RE: 204-210 Parramatta Road, Auburn, NSW 2144 – Facts and Contentions

In response to the Statement of Facts and Contentions (case no: 2022/00175835) raised by Cumberland City Council, Meinhardt Group has been engaged by Skematics to address all stormwater contentions identified in Part B – Contentions. The stormwater contentions raised by Council have been outlined below with responses provide by Meinhardt Group.

DRAINAGE LONGITUDINAL SECTION DRAINAGE LONG SECTION PITS EX-C1
SCALES: HORIZONTAL 1:200 VERTICAL 1:100

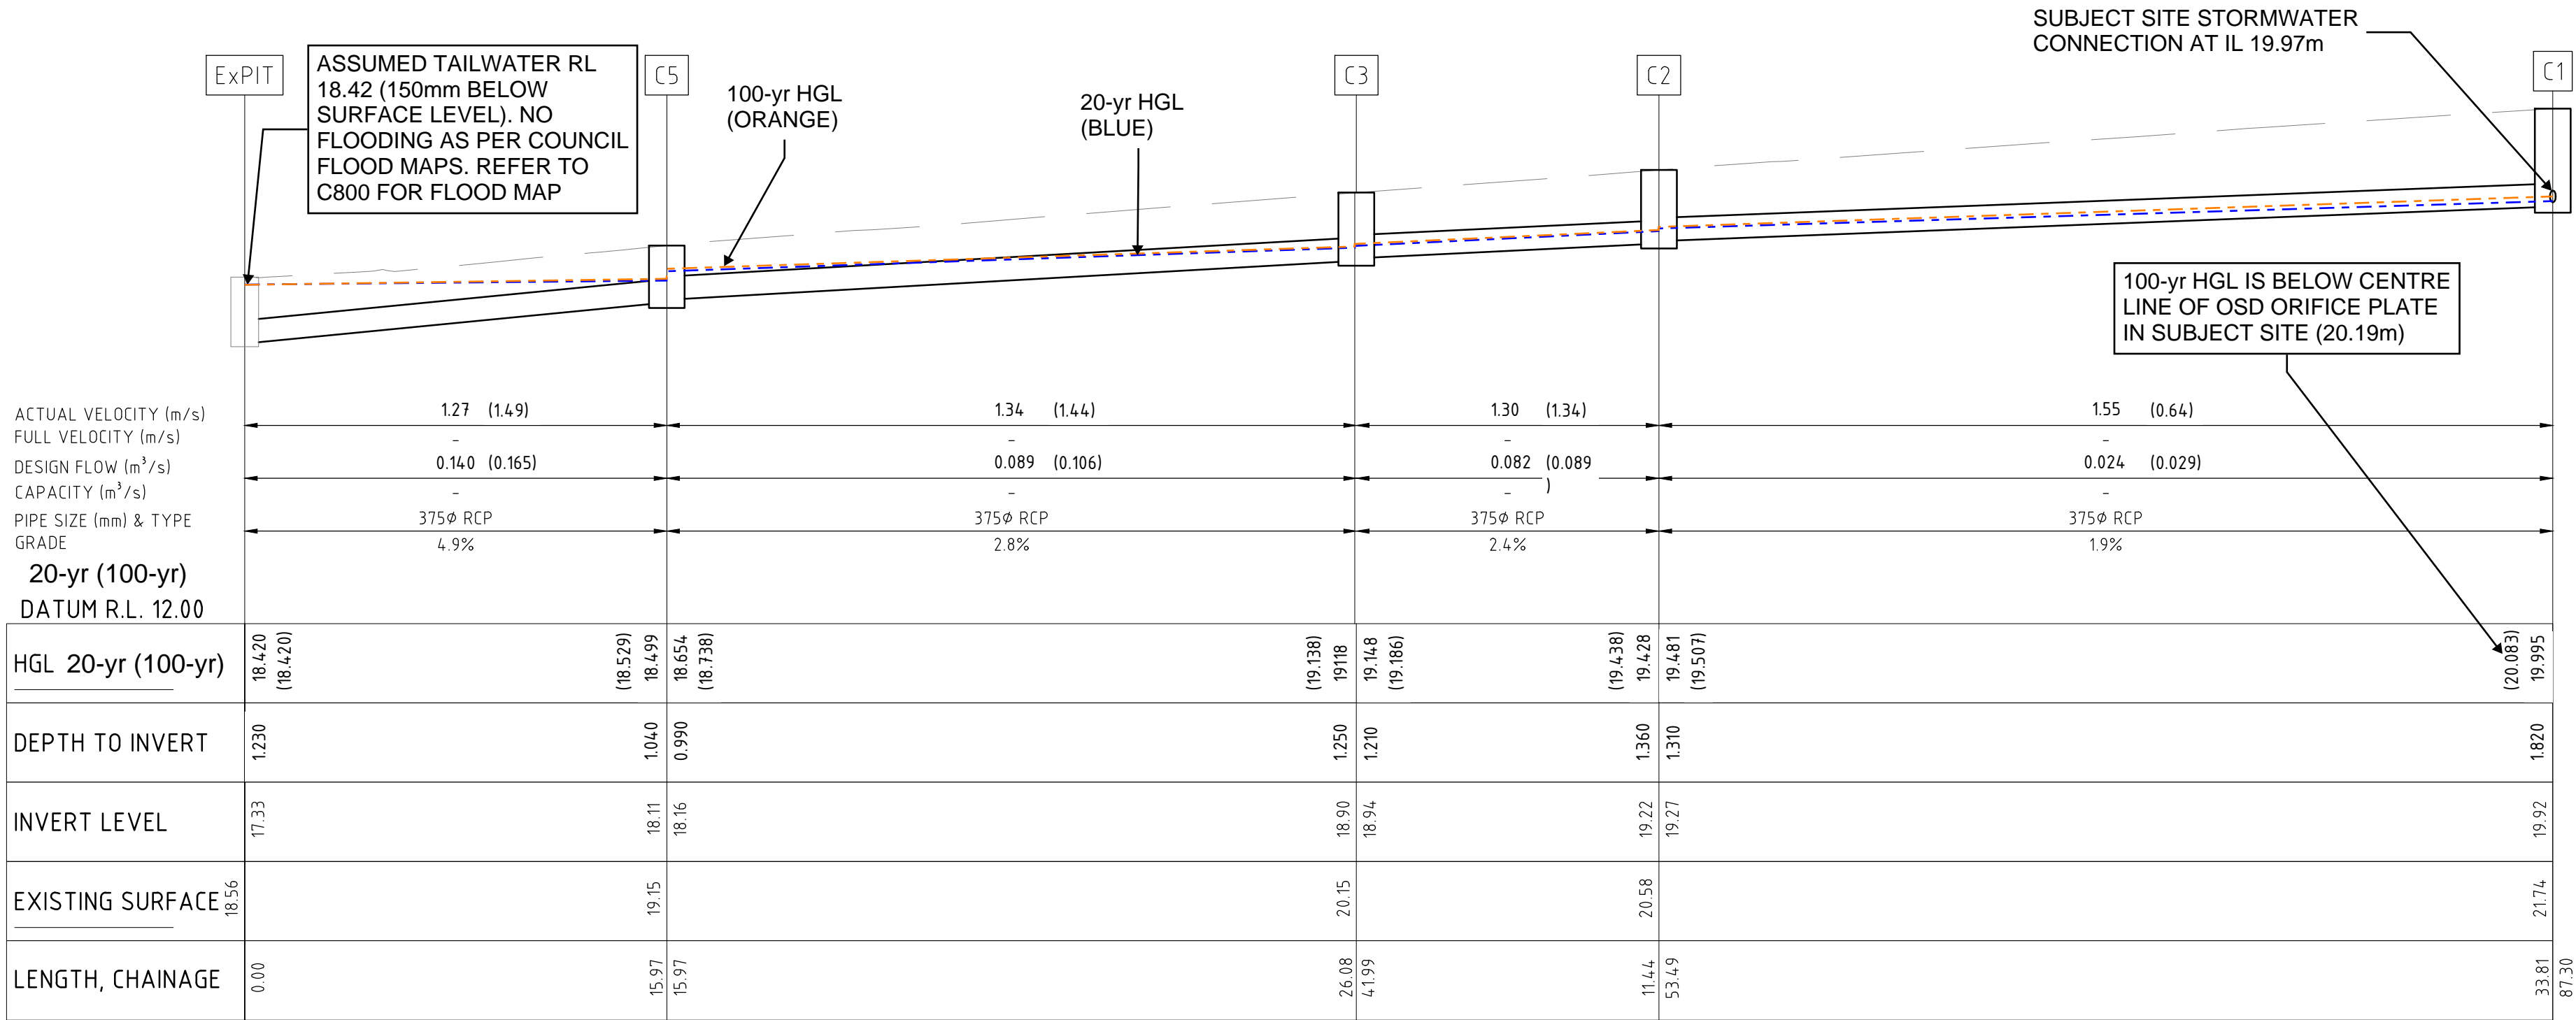
- (b) Fully detailed designs, including a long section of the pipe, a pipe trench cross-section detail and connection point into Council's drainage system, have not been submitted for all proposed drainage works within the road reserve. All the design details should be provided, including hydraulic grade lines based on the 5% and 1% AEP storms.

Refer to drawing sheet C210 for stormwater drainage long section, pipe trench cross-section detail. Refer to drawing sheet C102 for connection point into Council's drainage system. Refer to longitudinal section of the proposed stormwater drainage network for the hydraulic grade lines based on 5% and 1% AEP storms.
